Date: June 30, 2022
To: Design Review Board
From: Tony Leavitt, Senior Planner
File No.: DRV18-00493
Subject: **MADISON ROSE HILL MIXED USE PROJECT
MODIFICATION TO DRB DECISION**

ROSE HILL - DESIGN REVIEW MINOR MODIFICATION

ROSE HILL

DESIGN REVIEW UPDATES

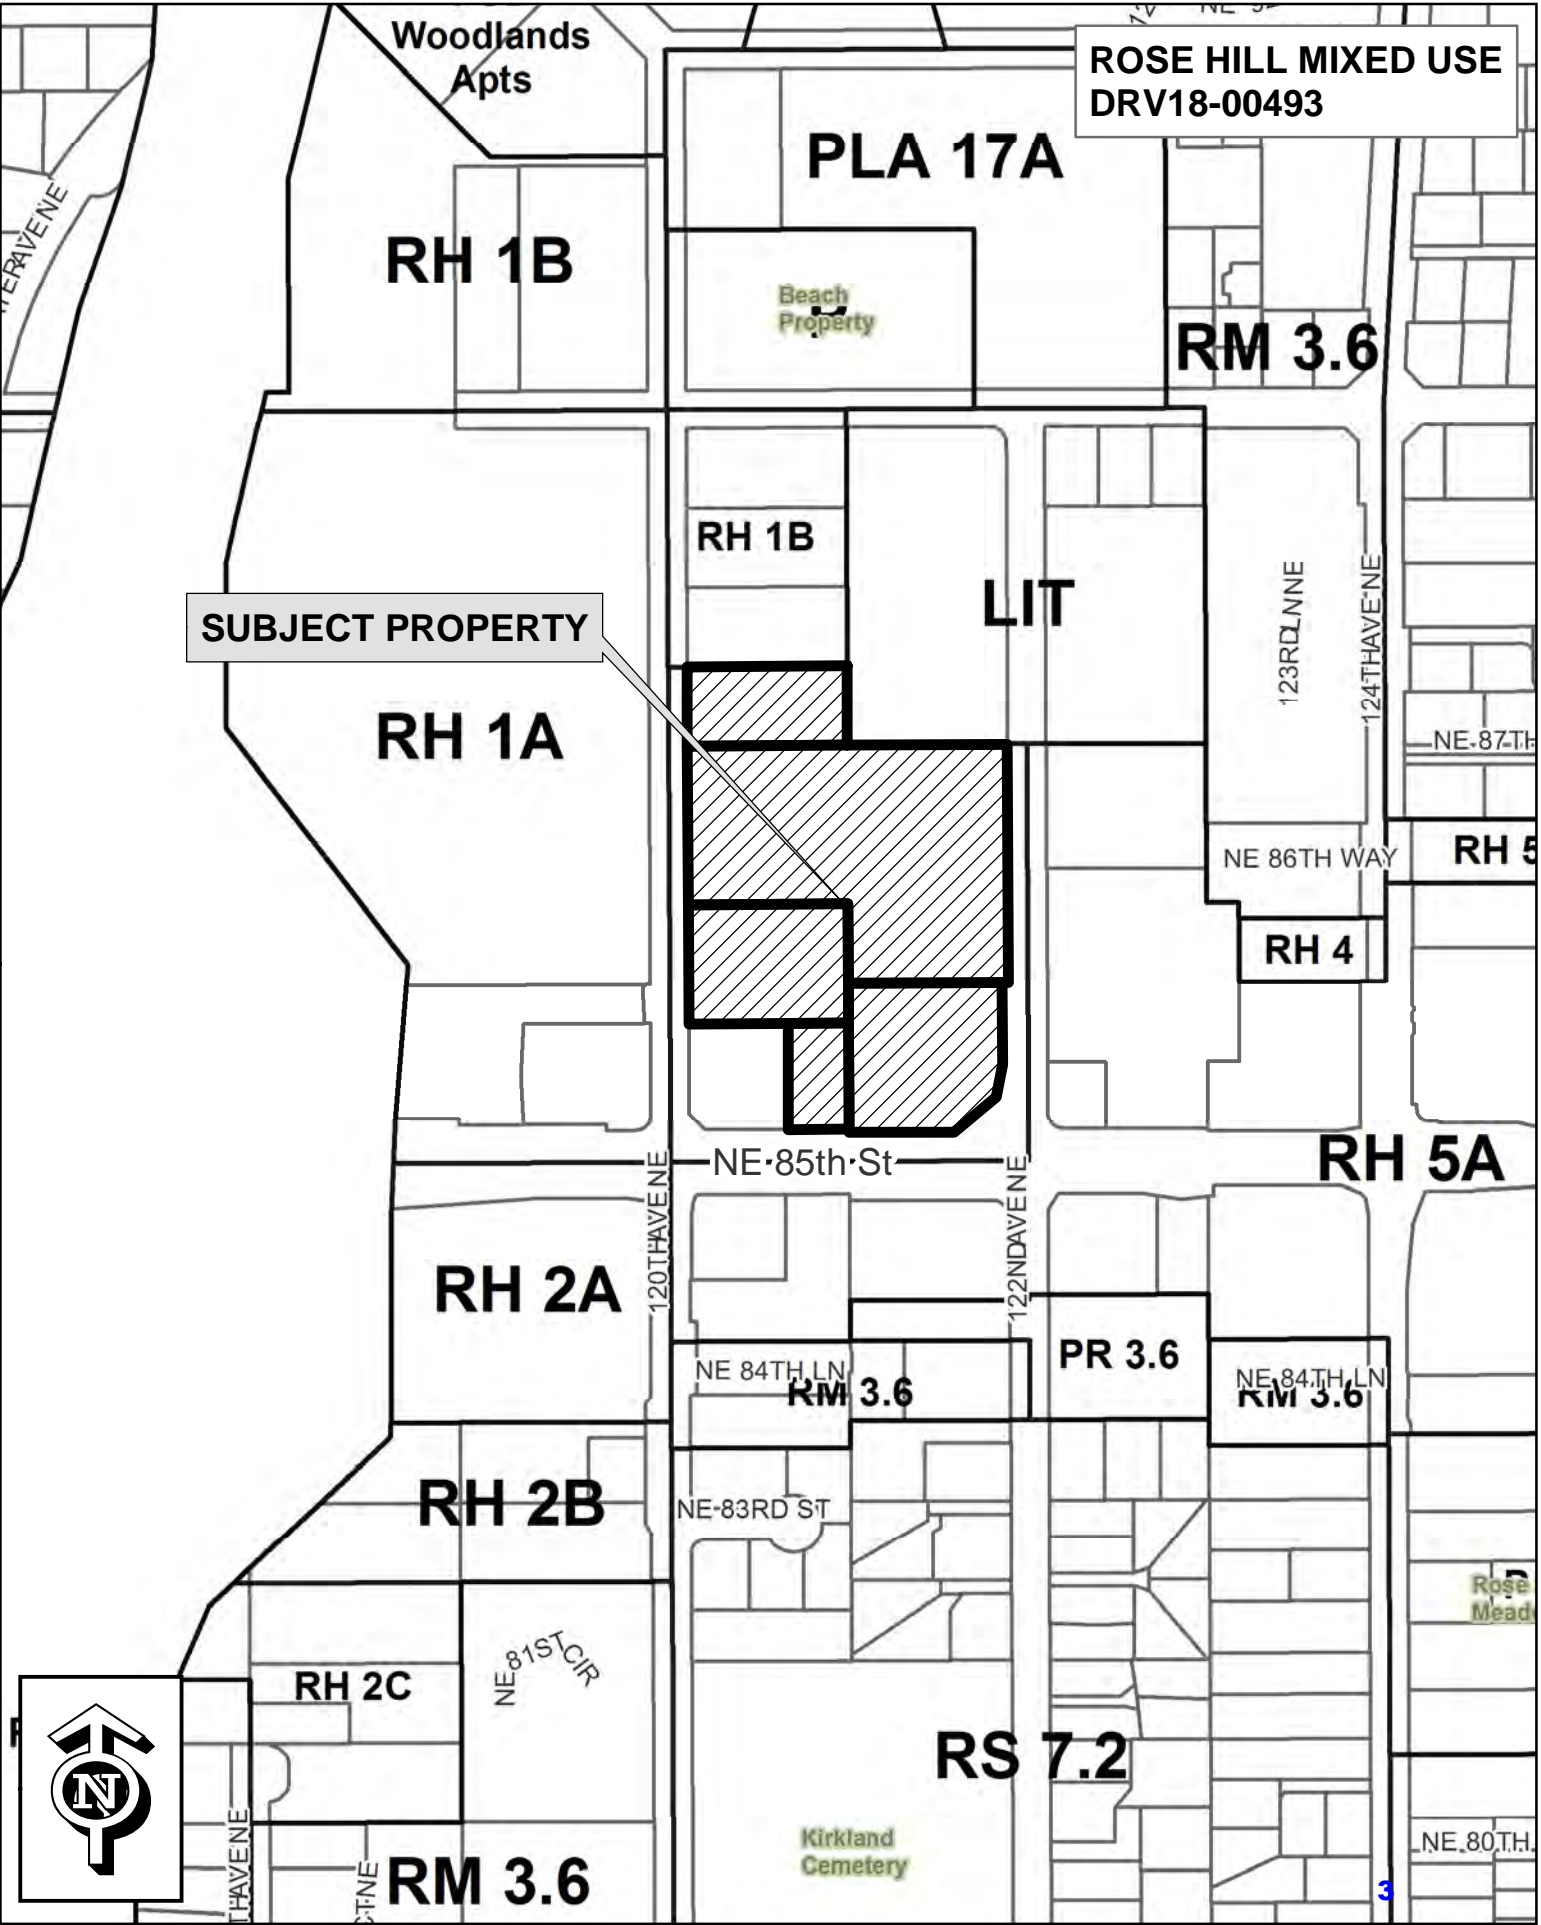
Building 1 (identified in Attachment 2, Sheets 4 through 10)

- Joint pattern changes around the entire building.
- Interior staircase rotated and pushed outward on the south elevation.
- Small massing change on the east and north sides of the building due to interior unit layout change.
- Material changes on the southern portion of the building from coregulated metal to flat metal panels and color.
- Color and siding changes along the west façade and the elimination of recessed balconies.
- Changes to the varying roof heights.

Building 2 (identified in Attachment 2, Sheets 11 through 18)

- Material and color changes along all facades.
- Changes to and the addition of balconies along the south residential façade.
- Massing change at the southwest corner.
- Changes to the commercial space at the southeast corner.
- Replacement of upper story residential single corner balconies with separated balconies.
- Changes to the east residential façade to match the west façade of Building 1.
- Reduction in the height of the northwest corner massing to meet Fire Department requirement.
